Interactive comment on “Scale effect on overland flow connectivity at the plot scale” by A. Peñuela et al.

A. Peñuela et al.

Received and published: 20 September 2012

Fig. 1. Microtopography types (2 m x 2 m detail) with depressions partially filled (stored water in blue)

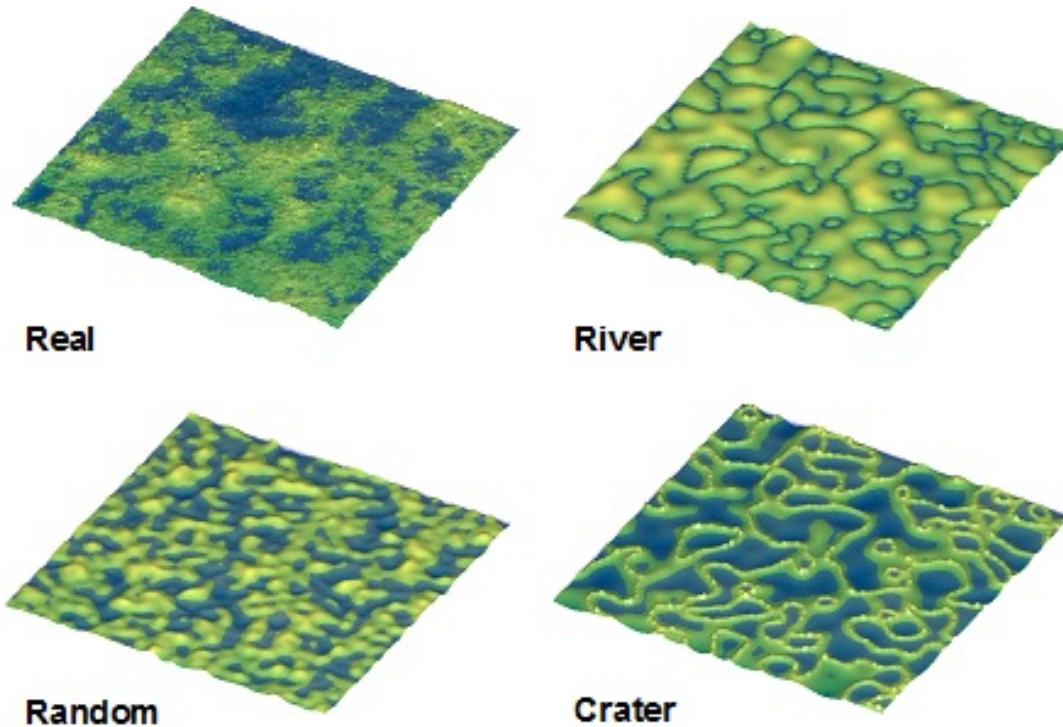
RC9:Figure 1 (page 7902) is not informative in its current form. Possibly a longitudinal transect would make the concept of River versus Crater more clear. There could be reduction in Figures. At this moment there are 17 moreover including composed figures.

AC9:We chose this format since we wanted to show the different spatial configurations and connectivity patterns of the fields, i.e., how micro-depressions are distributed and connected between each other. In our opinion, a longitudinal transect cannot properly

reflect the degree of connectivity between the depressions. The figure was modified to show the stored water over the field, in a similar way as Figure 2. In this way, it can be shown how the different parts of the field connect or disconnected to each other in the 4 different scenarios.
